Public Works Subcommittee
Meeting on 14 May 2019 – Follow-up Actions

**Legislative Council Public Works Subcommittee Meeting on 14 May 2019
LC Paper No. PWSC(2018-19)46 – Issues requiring Follow-up Actions**

原先設計—立面圖 Original Design – Elevation

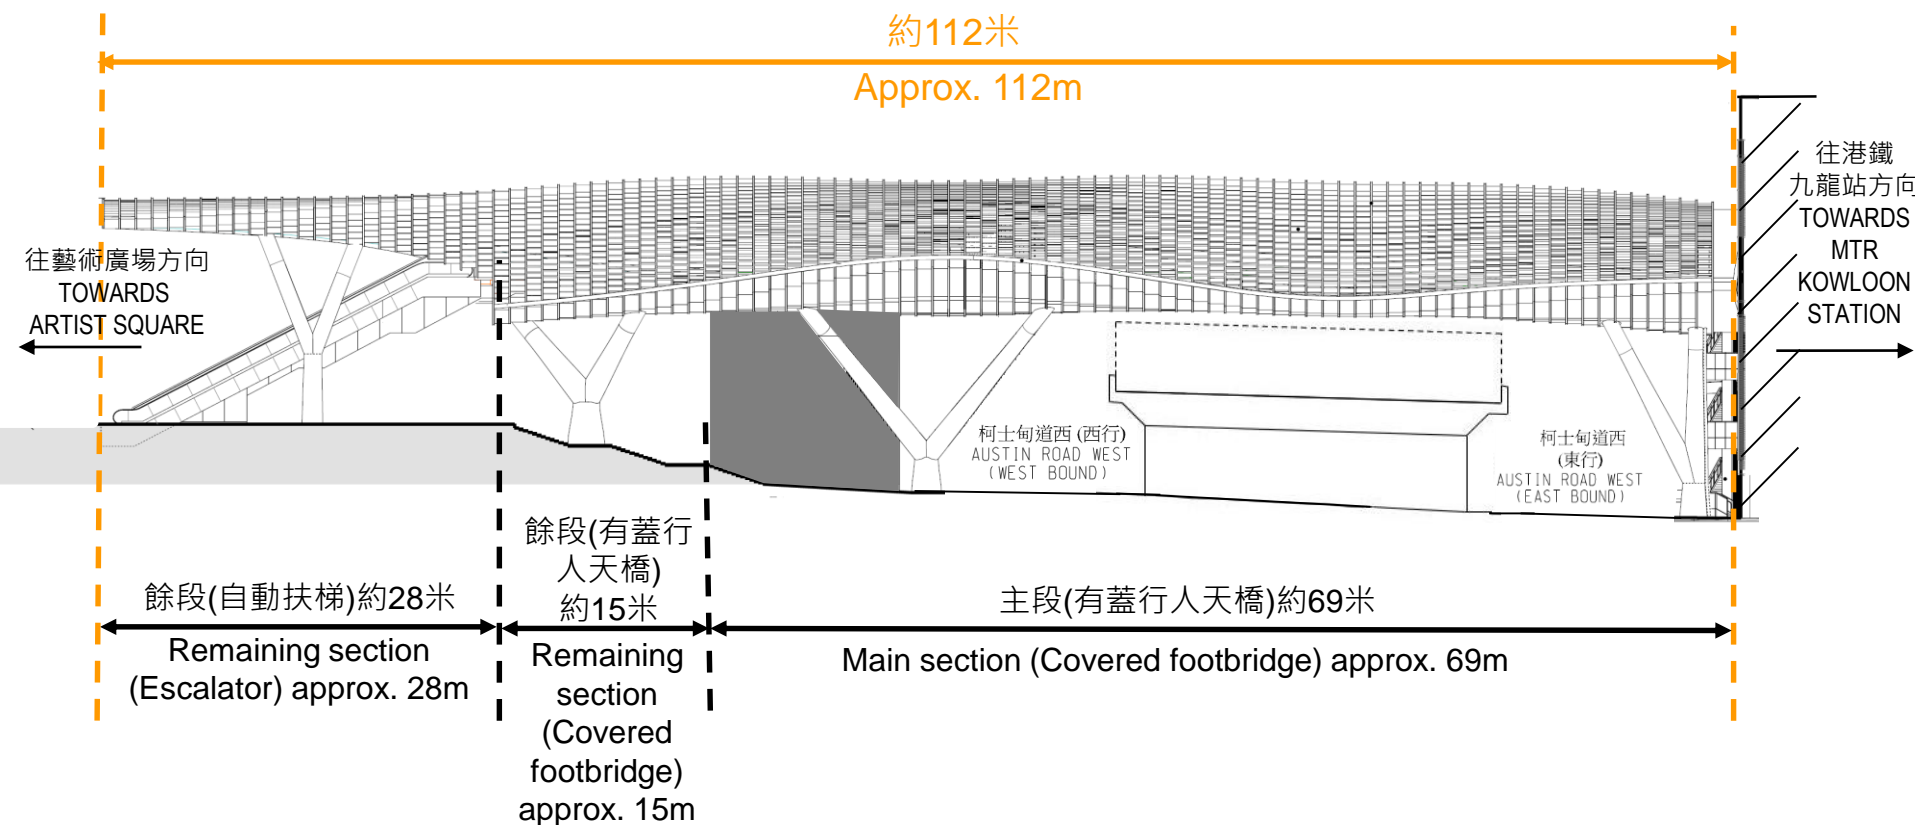
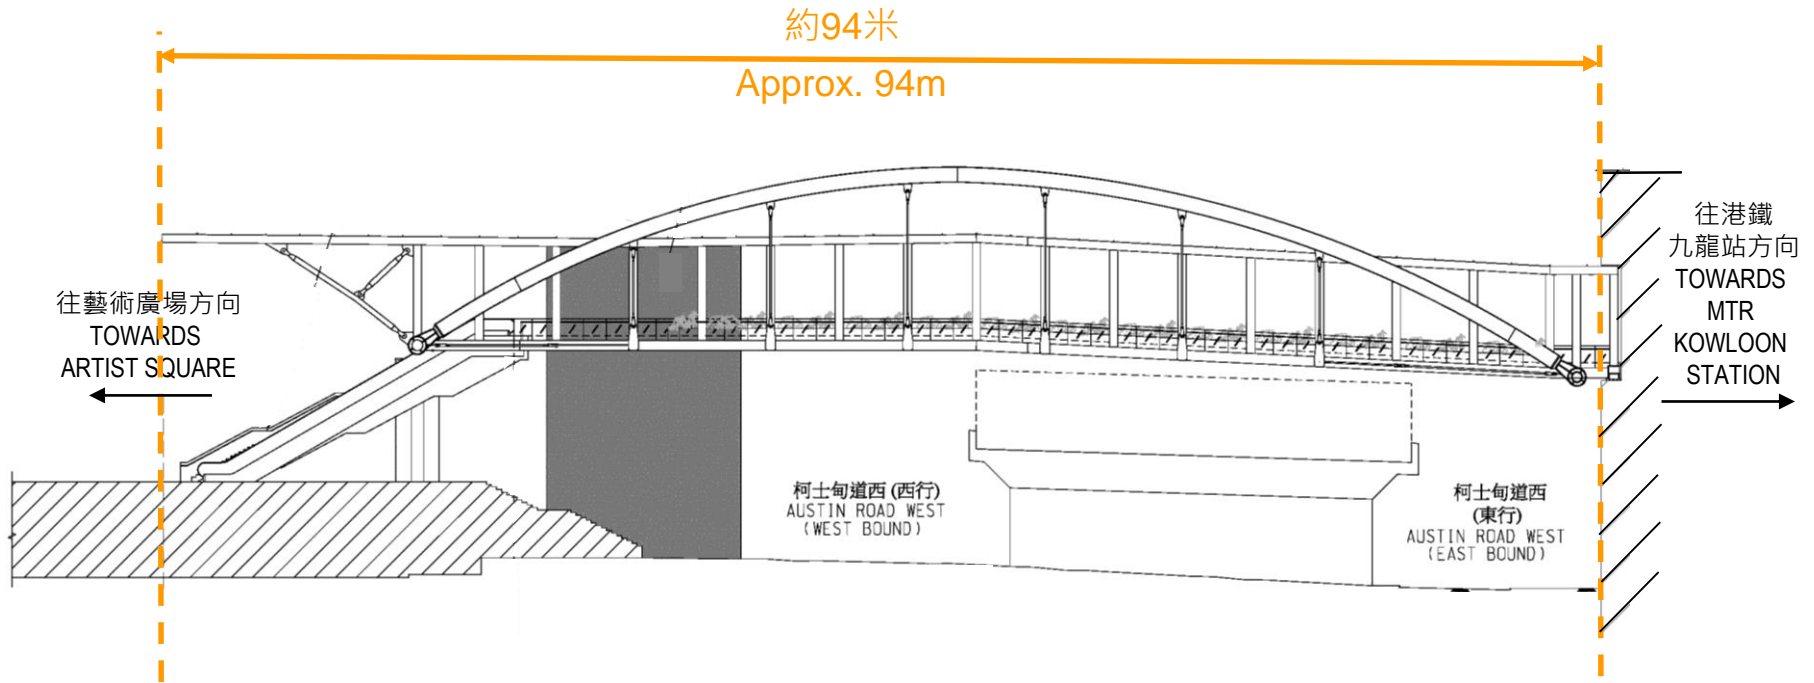
(c) the respective length of the original design and new design of the proposed footbridge with elaboration on the part being shortened by about 18 metre (m) in the new design as compared to the original design.

To sharpen visitors' sense of arrival in WKCD, the proposed footbridge in the original design extends into the central area of the Artist Square. In the new design, the landing location of the footbridge has been shifted from the central area to the northern side of the Artist Square. As shown on the elevations in **Annex 1** and **Annex 2**, the length of the proposed footbridge in the original design and new design are about 112m and 94m respectively. The overall length of the proposed footbridge is reduced by about 18m.
